Project Review

DATE: March 14, 2013
TO: Kevin Hsueh, Nuclear Regulatory Commission
FROM: John Callen, NDNR
SUBJECT: Crow Butte Resource, Inc. License Amendment Application for the Marsland Expansion Area In-Situ Uranium Recovery Satellite Facility in Dawes County, Nebraska; NRC Docket 40-8943.

Marsland Expansion Area (Docket No 40-8943)

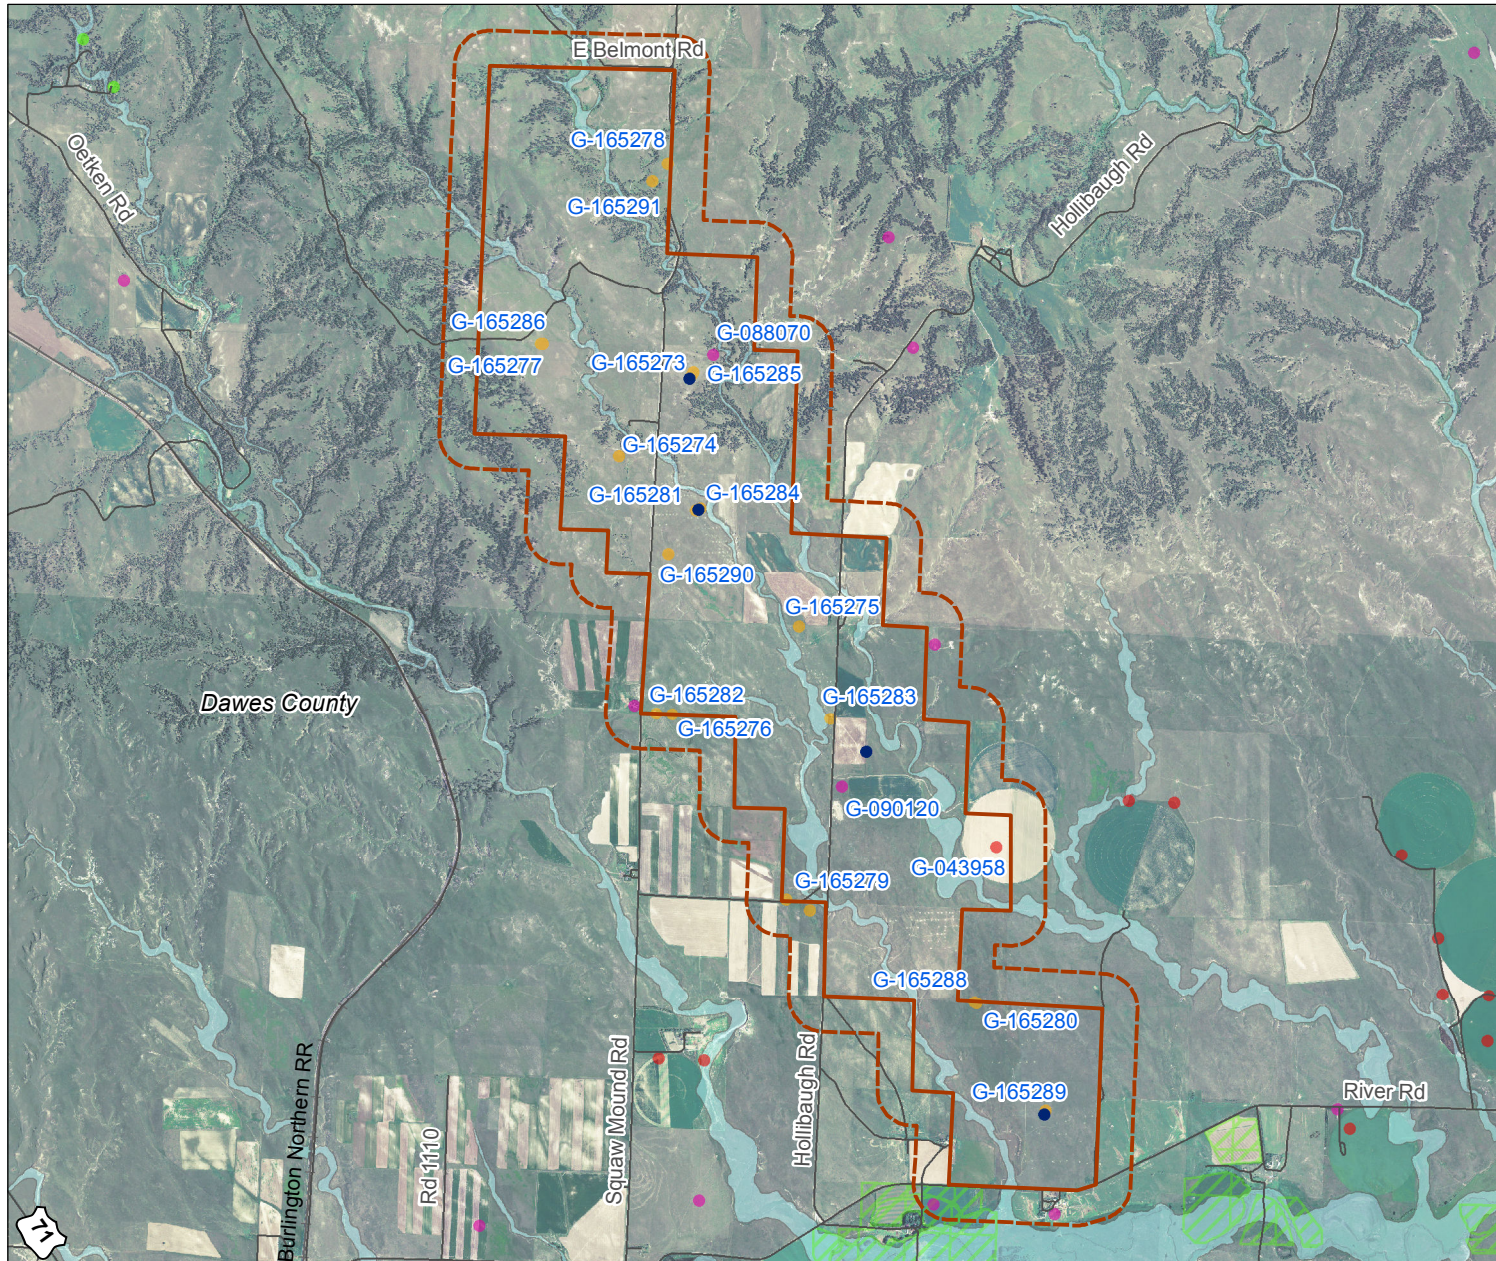
According to NDNR records, there are 21 registered wells within the proposed project area. Please find enclosed a figure depicting their registered location and name. Special care should be taken to locate and avoid impacting these wells in any significant way. In addition to registering the new wells proposed as part of this project with NDNR, if the status, use, or ownership of any other well changes due to the project, a water well registration modification form and/or a change of ownership form must be filed with the Department. Additionally, the appropriate Natural Resources District (NRD), which may have additional rules and regulations regarding such changes, should be notified. If you have any questions on groundwater well registration, please contact Pam Bonebright at 402.471.0572 or reference the groundwater links below.

A portion of the proposed project is located within the regulated (1% annual chance) floodplain and/or floodway, please see the attached figure. All development within a regulated floodplain and/or floodway needs to comply with local floodplain regulations, which includes obtaining a floodplain development permit. All new structures within the floodplain must be constructed with the lowest floor elevation at least one foot above the base flood elevation, or flood proofed to at least one foot above the base flood elevation (non-residential only). If you have any questions concerning floodplain management and permitting, please contact the local floodplain administrator, Roberta Coleman, at 308.432.0103 or dawescountyassessor@yahoo.com.
